Economic Commission for Europe**Inland Transport Committee****World Forum for Harmonization of Vehicle Regulations****Working Party on Passive Safety****Fifty-seventh session**

Geneva, 18-22 May 2015

Regulation No. 17 (Strength of seats)**Proposal for Supplement 4 to the 08 series of amendments to Regulation No. 17 (Strength of seats)****Submitted by the expert from the Netherlands ***

**Reg.17, par. 6.8.1.1.1.(Area 1) + par. 6.8.1.2.1.(Area 2):
In the case of separate seats without head restraints**

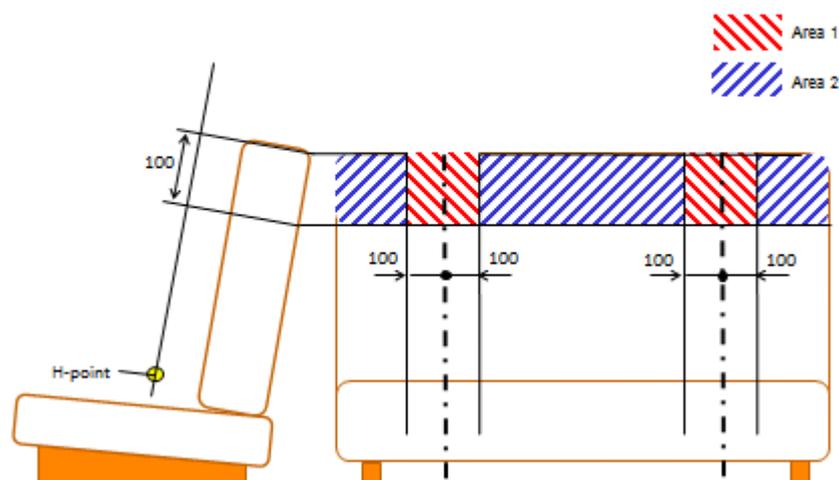
4. To cope with a wider forward displacement of the occupants, UN Regulation No. 17 should provide requirements concerning good energy absorption criteria for those areas of seat backs where the head of the rear occupant is to be impacted.
5. So far **only** Area 1 of impact, of the back seat is subject to energy absorption criteria. However, if Regulation No.16 allowed a broader forward displacement and therefore more possibilities of contact with rigid parts in front of the test dummy, then it would be necessary to also involve Area 2 of impact.
6. Area 1 is rather small to be tested. Figures of Area 1 and Area 2 for different seat configurations are indicated below to give a clearer view of the scope of the current proposal.
7. The proposed amendment to paragraph 5.2.3.2. is an editorial correction.

"5.2.3. The rear parts of seats, **including parts mounted on the seats**, situated as well in area 1, defined in paragraph 6.8.1.1. ~~below~~, **as area 2, as defined in paragraph 6.8.1.2.**, shall pass the energy dissipation test in accordance with the requirements of Annex 6 to this Regulation."

2.5 mm in area 1 **and area 2**,
~~5.0 mm in area 2~~,
3.2 mm in area 3.
